DOCKETED	
Docket Number:	23-AFC-01
Project Title:	Morton Bay Geothermal Project (MBGP)
TN #:	253190
Document Title:	Morton Bay Geothermal Project Data Request Response Set 1 (Revised Responses to Data Requests) Notice Letter to ICAPCD
Description:	N/A
Filer:	Lindsey Xayachack
Organization:	Jacobs
Submitter Role:	Applicant Consultant
Submission Date:	11/17/2023 1:27:43 PM
Docketed Date:	11/17/2023

RE: Notification for Permit Application to Construct for the Morton Bay Geothermal Project, Imperial County, California

Attachment A: Revised MBGP Well Layout

Figure 1-4R
Project Location
Morton Bay Geothermal Project
 Imperial County, California

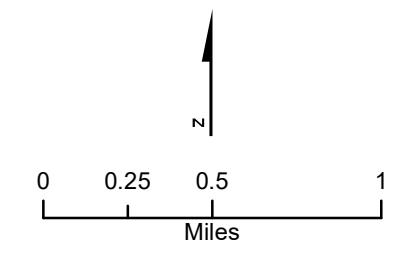
Recent updates have been made to the MBGP design which were not able to be incorporated into the revised analyses submitted on November 10, 2023. Specifically, the location and orientation of the offsite wells and associated well pads have shifted. A figure showing the latest MBGP well design layout is included as Attachment A.

These minor layout changes only pertain to offsite emission sources with limited operation and the number of offsite wells has remained the same. Therefore, the emission estimates, air quality impact analyses, and health risk assessment modeling submitted to ICAPCD on November 10th are considered to be conservative as well as representative of the updated MBGP design. For these reasons, the Applicant will not be submitting revised analyses for the updated MBGP design.
